FACPAC Contract Change Order

Tier 1 Project: CHHS Phase 2
BG Number: 23-403
Status: Active

CHANGE ORDER NUMBER: 1-3
INITIATION DATE: 12/12/2025

PR029 – Display Cases to Closets

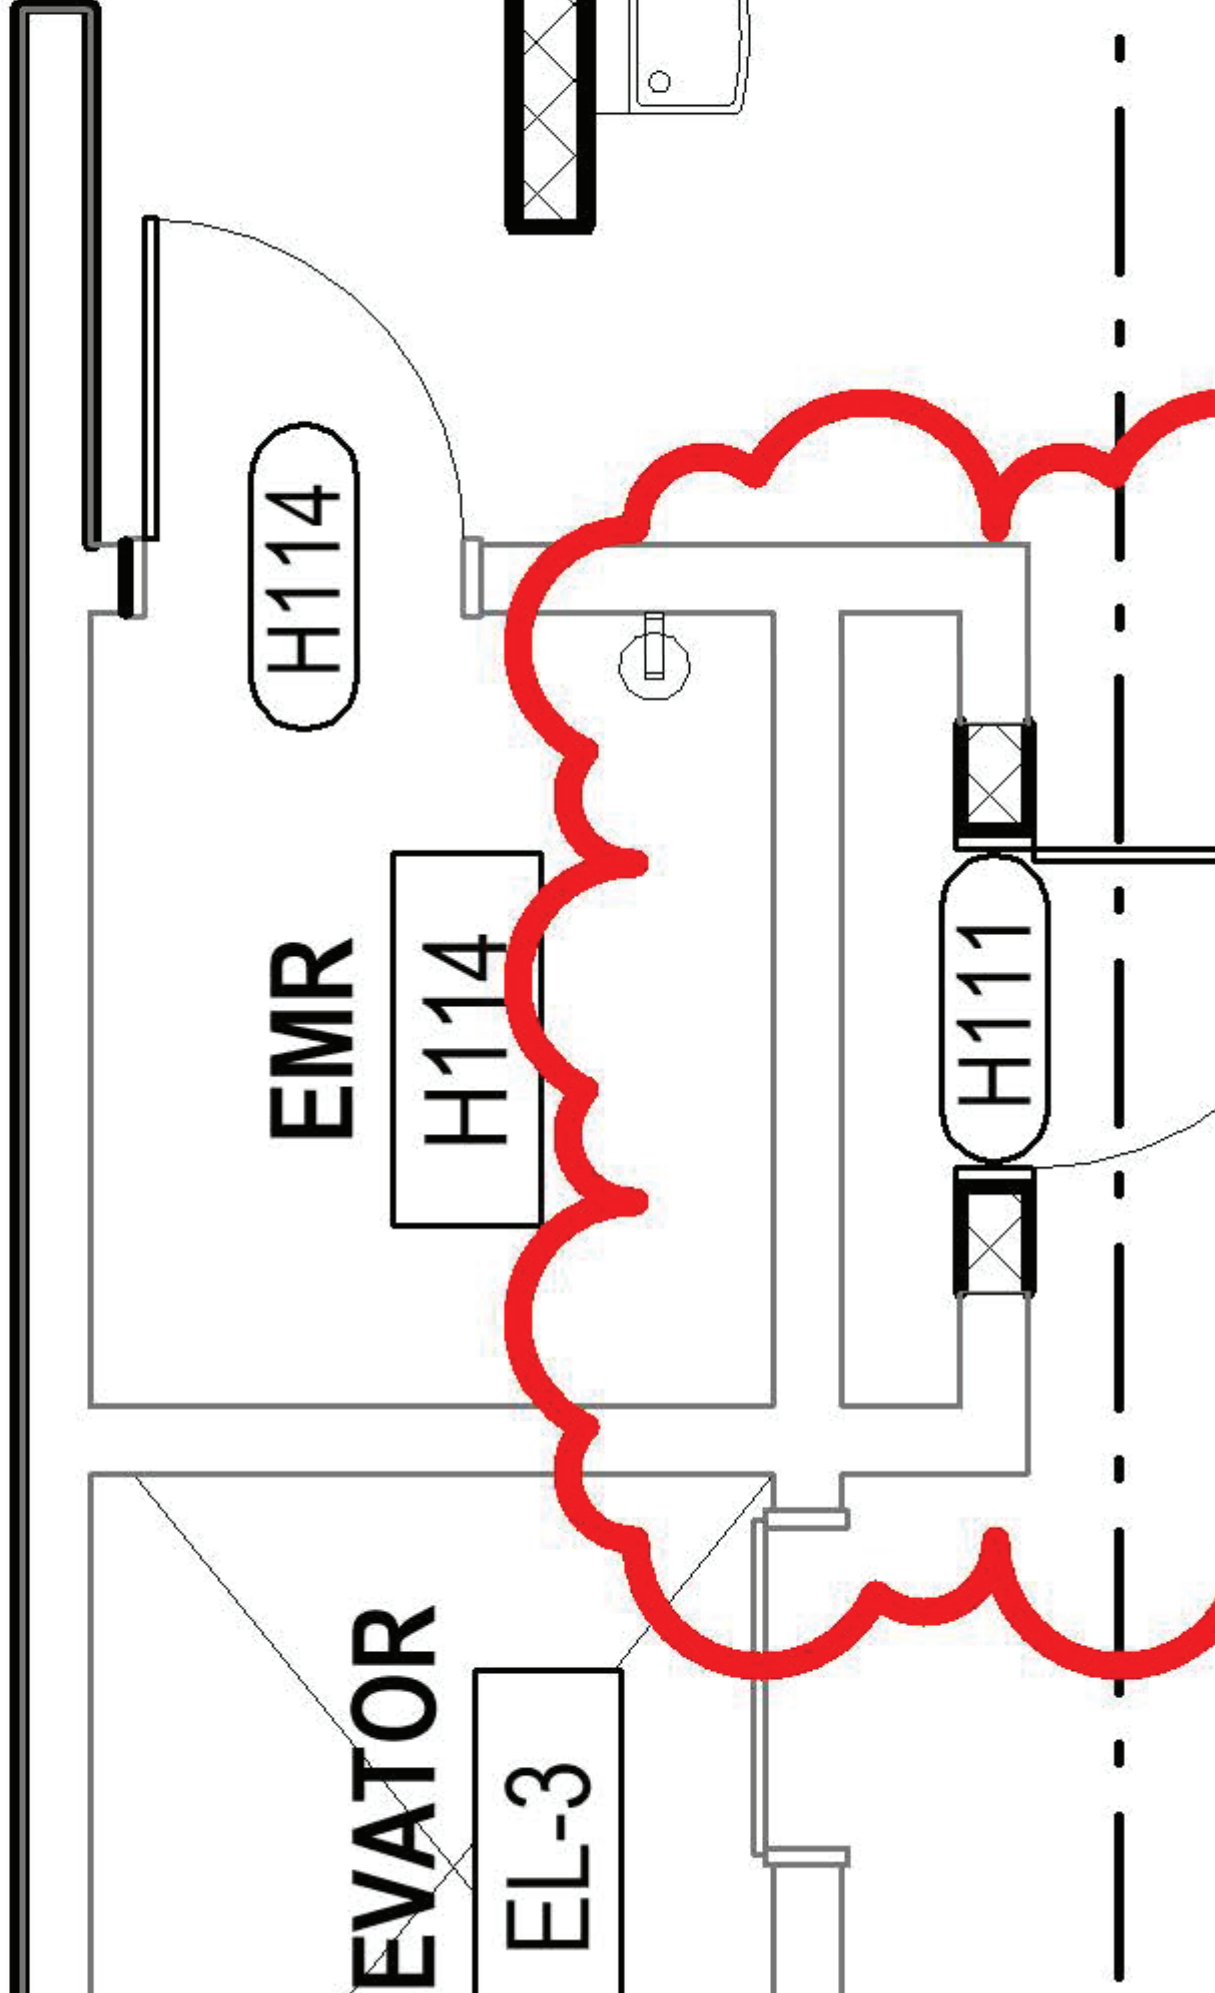
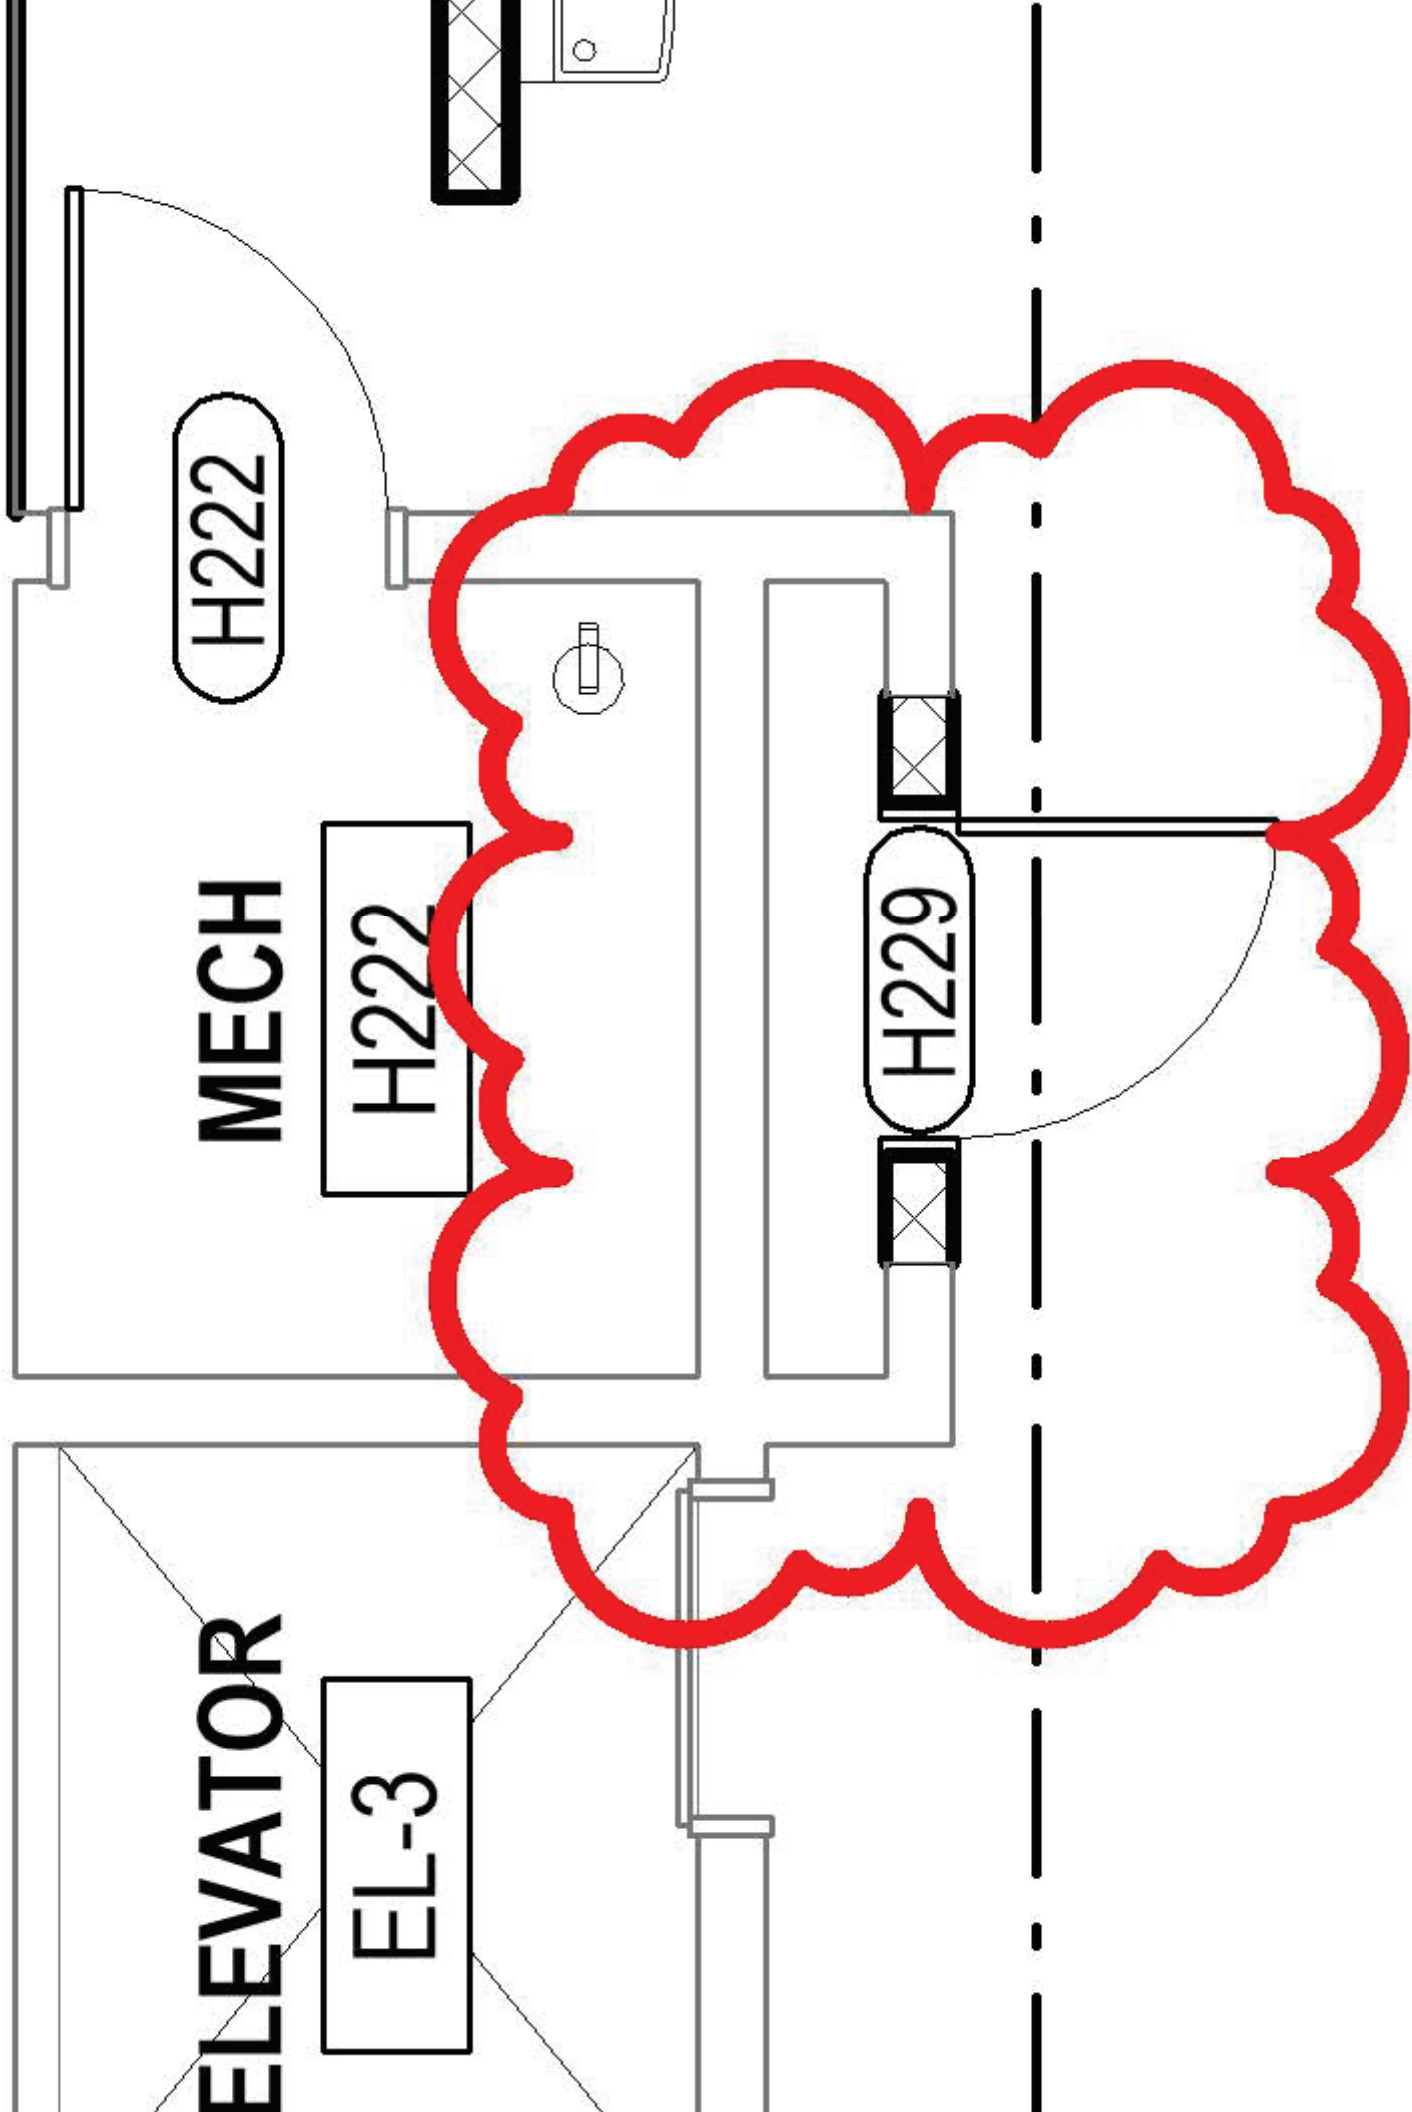
The owner would like to remove 2 display cases and turn them into closets.

Provide pricing for demolition of the sliding window, CMU below and bottom of display case. Provide a 3'-0" by 7'-2" single "Type F" wood door with hollow metal frame.

Match door hardware on H215A door. Infill with CMU as required.

Match adjacent finishes and paint interior of room P-1, add B-1 rubber base, RT-1 rubber flooring and add light fixture.
